BID ADDENDUM #1

**Drama / Music Buildings Reroof Project
California State University Stanislaus
One University Circle, Turlock, CA 95382**

Bid / Project Number: 12-202
Bid Opening Date: April 30, 2013
Bid Opening Time: 2:00 p.m.

DRAMA BUILDING
LOWER ROOF
NOT TO SCALE

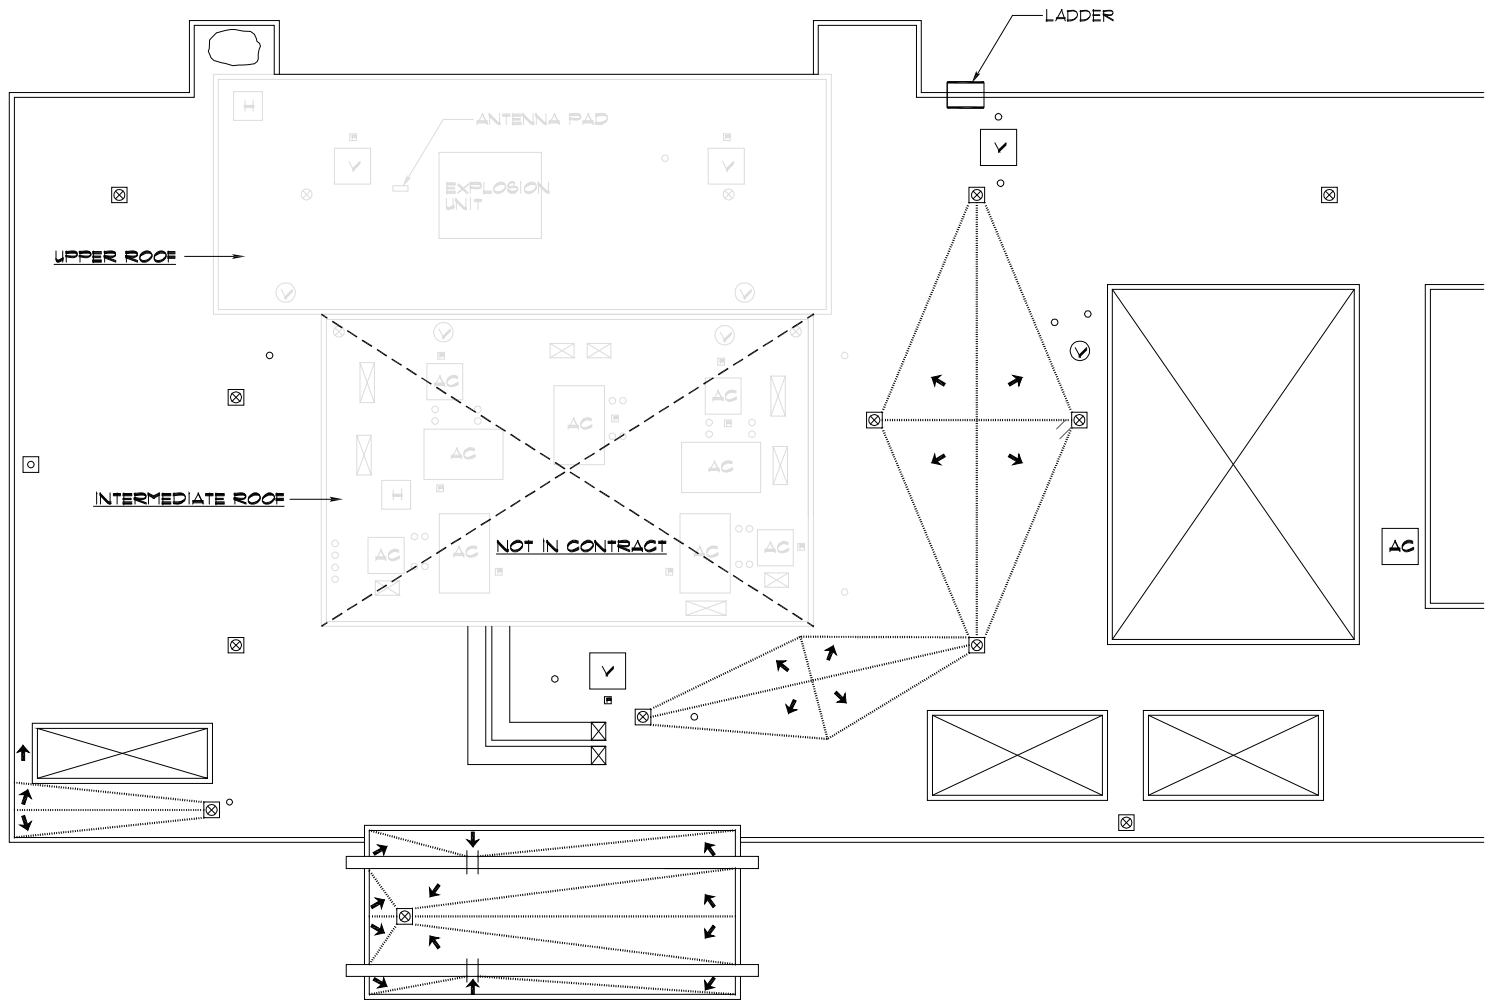
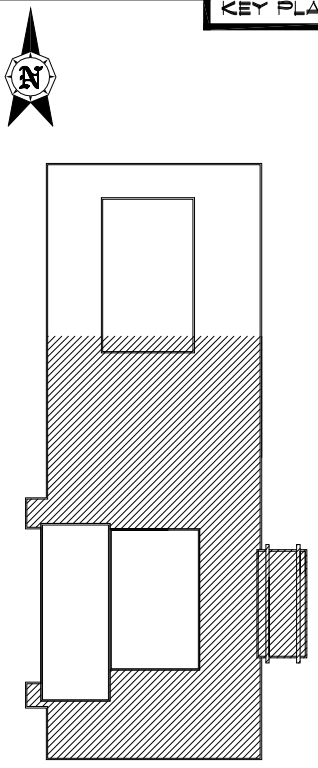
- 1.0** The tapered insulation areas are illustrated on attached roof plan(s). All dimensions, shop drawings and areas shall be submitted per Section 01300, Submittals. The roof plans depict the low spots and "possible solutions" for minimizing ponding water on the roofs. The contractor is responsible for verifying site dimensions. Refer to Details RP1, RP2, RP3, dated 04.22.13.
- 2.0** The pre-cast plaster/stucco panels shall NOT be modified to accommodate height of base flashing. Refer to Detail 3, dated 04.22.13.
- 3.0** The concrete panels shall be counter flashed per Detail 2, dated 04.22.13.
- 4.0** The walls of the Upper Roof of the Drama Building shall be clad with reinforced membrane per Detail 16, dated 04.22.13
